# UNITED STATES PATENT AND TRADEMARK OFFICE

APPLICATION NO.	FILING DATE	FIRST NAMED INVENTOR	ATTORNEY DOCKET NO.	CONFIRMATION NO.
10/730,645	12/08/2003	Kenneth Adams	03-150	2957
719	7590	03/23/2006	EXAMINER	
CATERPILLAR INC. 100 N.E. ADAMS STREET PATENT DEPT. PEORIA, IL 616296490			DEVORE, PETER T	
			ART UNIT	PAPER NUMBER
			3751

<b>Office Action Summary</b>	Application No. 10/730,645	Applicant(s) ADAMS ET AL	
	Examiner Peter T. deVore	Art Unit 3751

## DETAILED ACTION

Annotated Parks Fig. 1

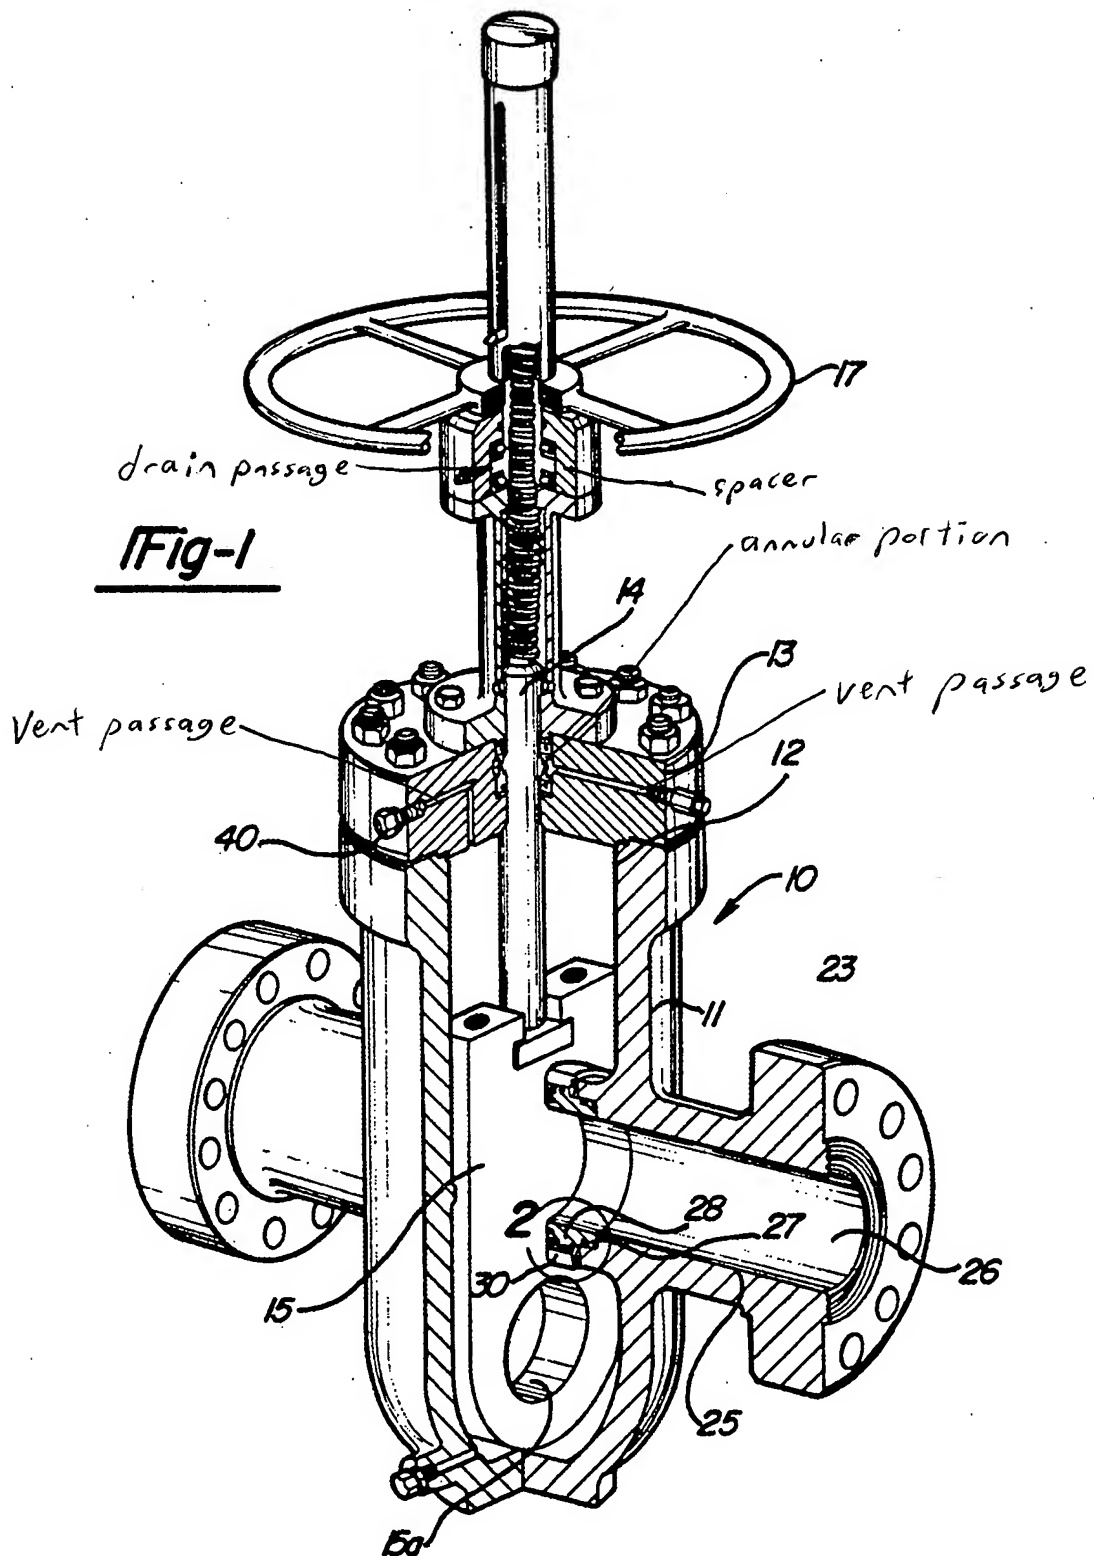
Claims 1-4 and 6 are rejected under 35 U.S.C. 102(b) as being anticipated by Parks.

The Parks reference discloses a fluid control valve comprising a body 10, first and second fluid passages (the main inlet and outlet of the body, see Fig. 1), a movable member (stem 14 and valve element 15) within a bore (see Fig. 1), an actuator 17, and a plurality of vent passages, an annular portion, a spacer, and a drain passage (see attached annotated copy of Fig. 1).

Annotated Roberson Fig. 1

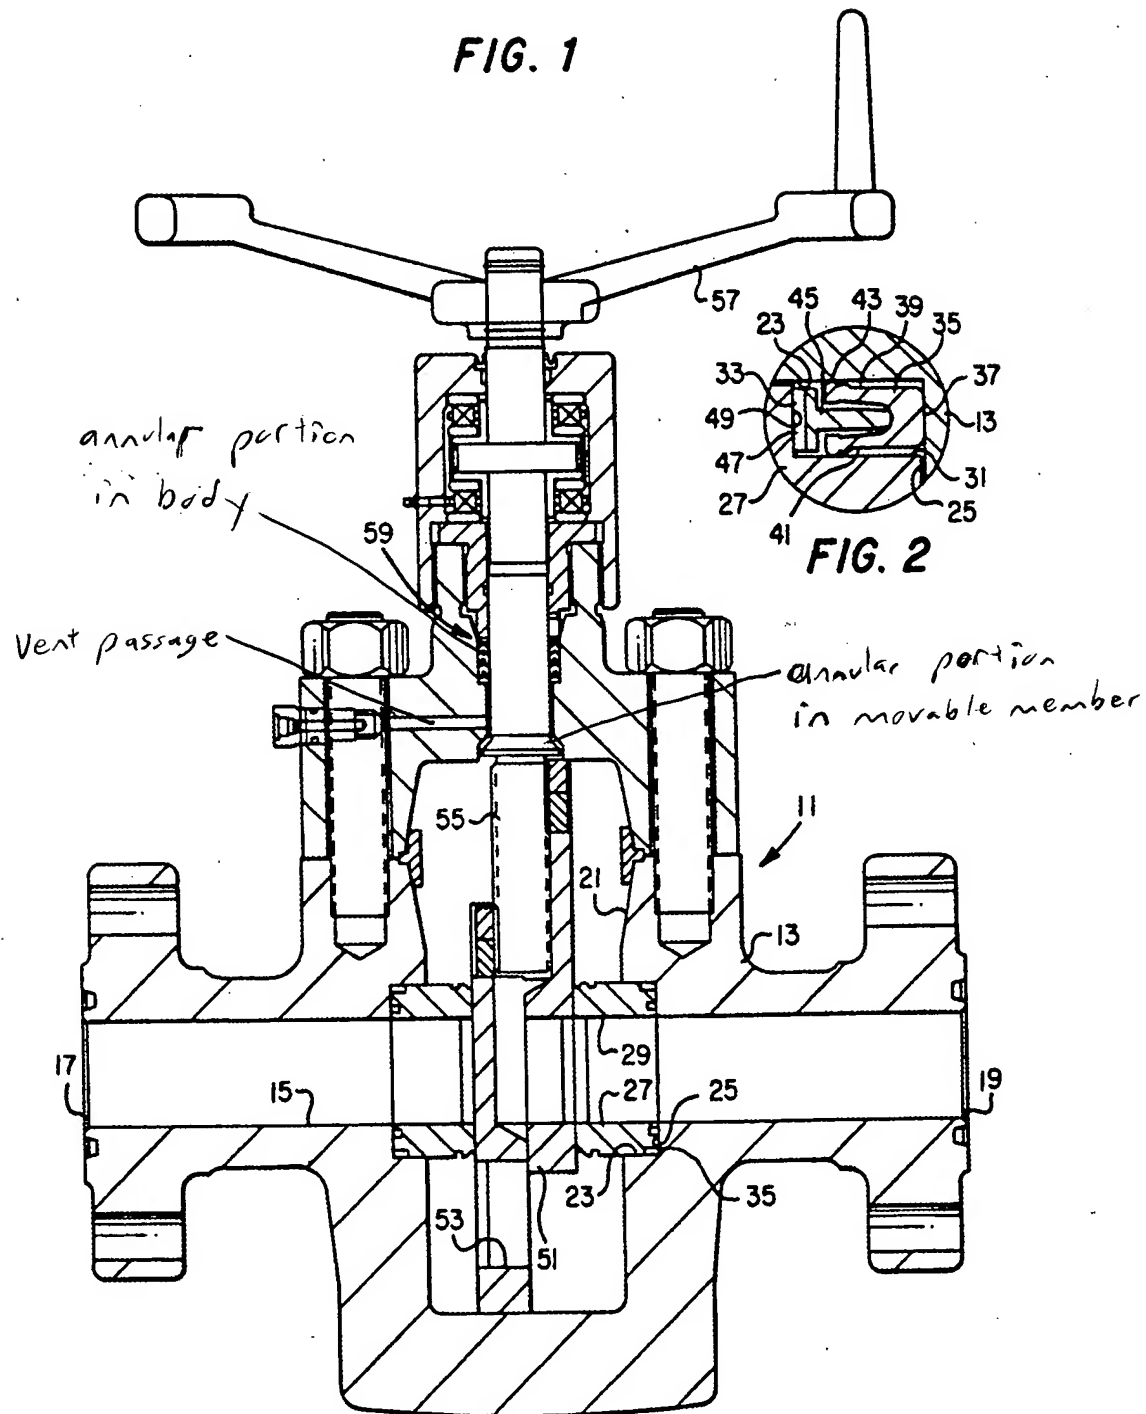
Claims 1, 2, 4, and 5 are rejected under 35 U.S.C. 102(b) as being anticipated by Roberson.

The Roberson reference discloses a fluid control valve comprising a body 11, first and second fluid passages 17 and 19, a movable member (stem 55 and valve element 51) within a bore (see Fig. 1), an actuator 57, and a vent passage and annular portions in the body and movable member (see attached annotated copy of Fig. 1).
